Access Compliance Report Public Rights-of-Way (Curb Ramps)

Main Street: ETHEREAL_ST Cross Street: TANGO_LN Location: W

ADA ID: RPRK211027133546 Ramp Type: Type 4 - Parallel Initial Pass/Fail: Fail Overall Compliance: No Severity Score: 2

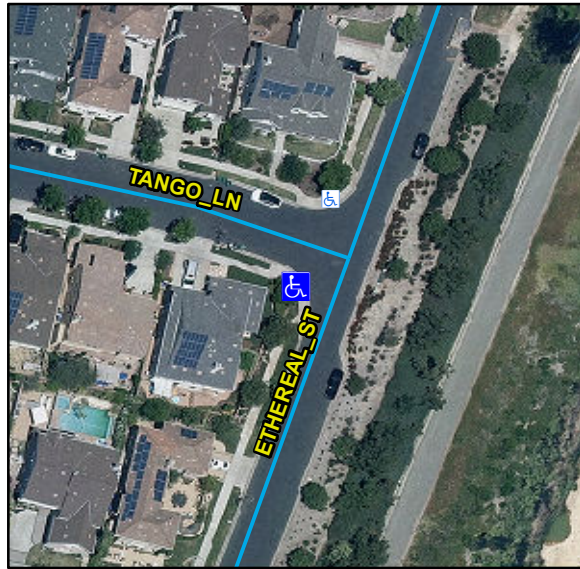
Compliance	Description	Data	Compliance	Description	Data
N/A	Ramp Length LT (in)	131	N/A	Ramp Length RT (in)	128
Yes	Ramp Width LT (in)	53	Yes	Ramp Width RT (in)	52
Yes	Ramp Run Slope LT (%)	3.8	Yes	Ramp Run Slope RT (%)	4
Yes	Ramp Cross Slope LT (%)	1.7	No	Ramp Cross Slope RT (%)	2.9
N/A	Landing Present	N/A	N/A	DWS Provided	N/A
N/A	Landing Length (in)	N/A	N/A	DWS Contrast	N/A
N/A	Landing Width (in)	N/A	N/A	DWS Length (in)	N/A
N/A	Landing Run Slope (%)	N/A	N/A	DWS Full Width	N/A
N/A	Landing Cross Slope (%)	N/A		DWS Offset Type	N/A
N/A	Landing Movement Obstructed?	N/A	N/A	DWS Offset Left (in)	N/A
	Landing Movement Type	N/A	N/A	DWS Offset Right (in)	N/A
N/A	Landing Shared	N/A			
N/A	Clear Space	Yes			
N/A	Clear Space To Crosswalk (in)	N/A			
N/A	Marked Crosswalk 1	No	N/A	Marked Crosswalk 2	No
	Crossing 1 Direction	SE		Crossing 2 Direction	NE
	Marked Crosswalk 1 Width (in)	N/A		Marked Crosswalk 2 Width (in)	N/A

Remove & Replace Curb Ramp With Two New Directional Ramps or Equivalent.
